PUBLIC HEARING
Before the Planning & Zoning Commission
Meeting of May 14, 2024

PUBLIC HEARING ITEM
STAFF REPORT

Subdivision Preliminary Plat approval for The Laurels Subdivision located at 0, 0 Southside Blvd, two parcels #R3230800000 and R3230601000 totaling 5.15 acres in the RD (Two-Family Residential) zoning district (located in the SE 1/4 of the NE 1/4 of Section 35, T3N, R2W, BM) for Centurion Engineers, Inc./David Crawford representing SSM2 Company (SPP-00141-2023).

DATE: April 5, 2024
TO: Nampa Planning & Zoning Department
FROM: Caleb LaClair, P.E. – Assistant City Engineer
CC: Daniel Badger, P.E. – City Engineer
CC: Tom Points, P.E. – Public Works Director
**SUBJECT: SPP-00141-2023 – The Laurels Subdivision
Engineering Review Memo**

Diagram of a Typical 50-Foot Local Street Section. The diagram shows a cross-section of a street with various components and dimensions. Key features include:

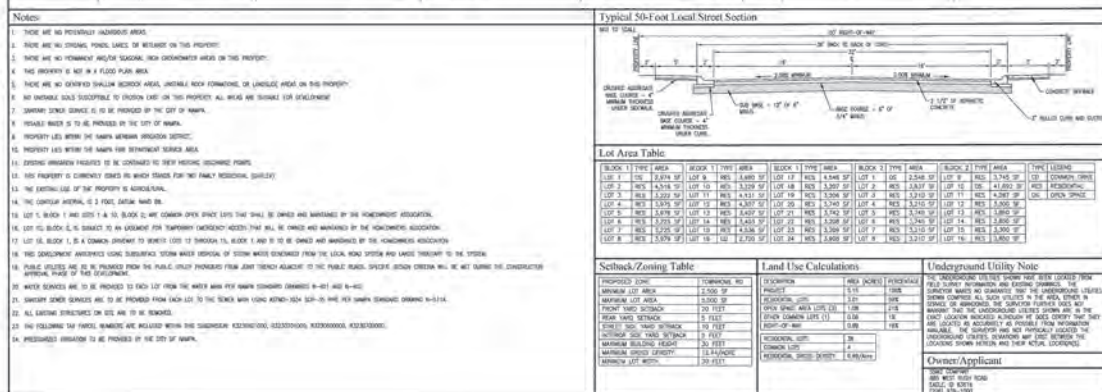
6. Developer shall convert the northerly drive aisle to a standard half section public road to support shared access for the property to the north.
7. Any onsite wells or septic systems shall be abandoned and/or removed in accordance with Local and State regulations at the time of individual property development/redevelopment and prior to connection to applicable City services.

3. Developer shall convert the northerly drive aisle to a standard half section public road to support shared access for the property to the north.
4. Any onsite wells or septic systems shall be abandoned and/or removed in accordance with Local and State regulations at the time of individual property development/redevelopment and prior to connection to applicable City services.
